Village of Arlington Heights
Plan Commission
Board Room
Arlington Heights Village Hall
33 S. Arlington Heights Road
Arlington Heights, IL 60005
July 22, 2015
7:30 PM

- A. T-Mobile - 1000 S. Arlington Heights Rd. - PC#15-003
(continuation from 5/13/15)
Special Use Permit for a Wireless Antenna Tower
- B. Verizon Wireless Antenna at Luther Village - 800 W. Oakton St. -
PC#15-009
Special Use Permit for Rooftop Wireless Antenna

To: Plan Commission
Prepared By: Latika Bhide, Development Planner
Meeting Date: July 22, 2015
Date Prepared: July 16, 2015
Project Title: T-Mobile
Address: 1000 S. Arlington Heights Road

CONCEPT LANDSCAPING PLAN

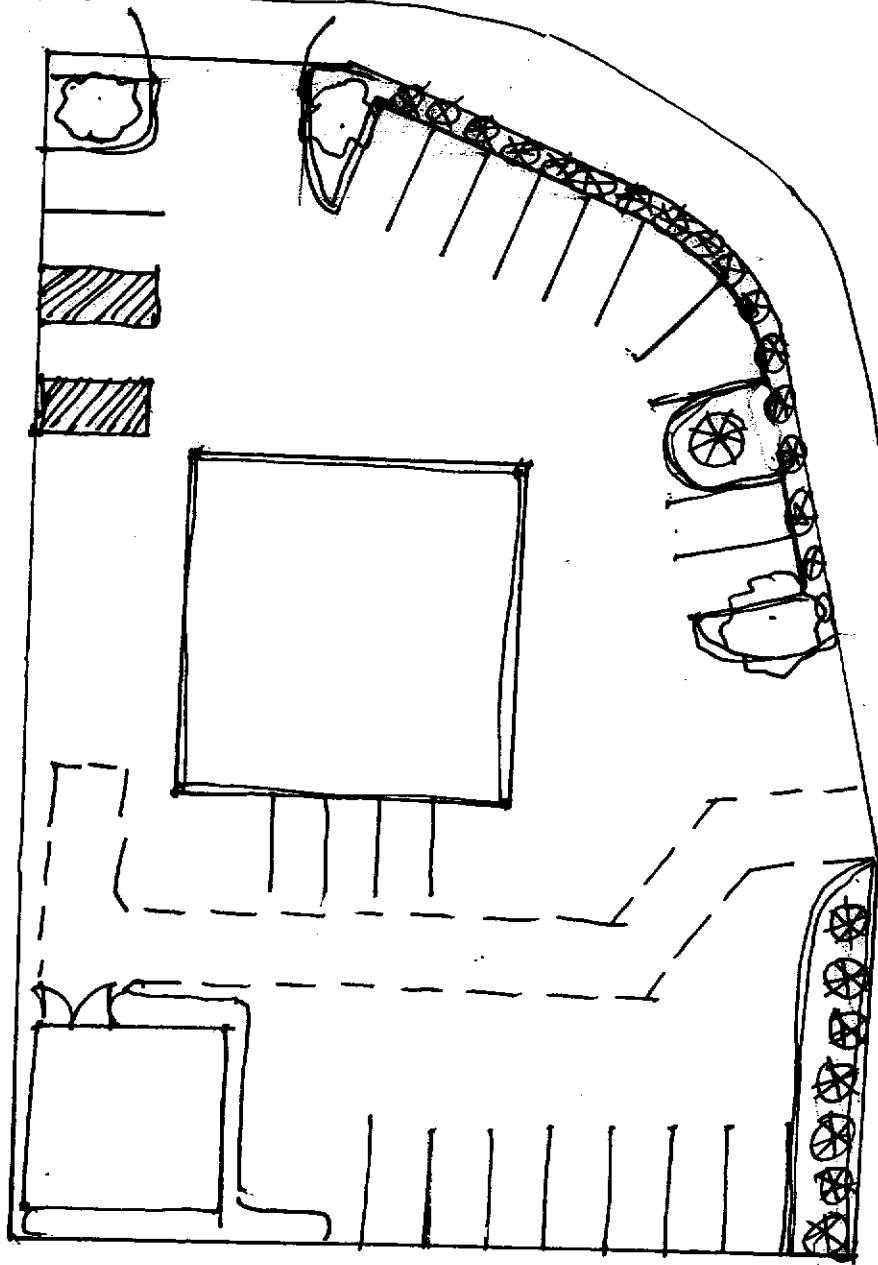
- 1) Indicate the size (at time of planting) of the proposed Mission Arborvitae on sheet LE-2.1.
- 2) Provide a 3' high drought/salt tolerant screen along Central Avenue and Arlington Heights Road in order to buffer the parking lot along the street frontage (Chapter 28, section 6.15-1.2a). Providing a 3 foot high screen may require IDOT's approval for landscaping located in the IDOT right-of-way.
- 3) The ends of all parking rows must include a landscape island, which contains a 4" caliper shade tree (Chapter 28, section 6.16-1.2b). Provide landscape islands at the ends of all parking rows.
- 4) Along the west property line, the existing 6 foot high wood fence is in poor condition. It is recommended that the fence be replaced.

Comment: Indicate the size (at time of planting) of the proposed Mission Arborvitae on sheet LE-2.1.
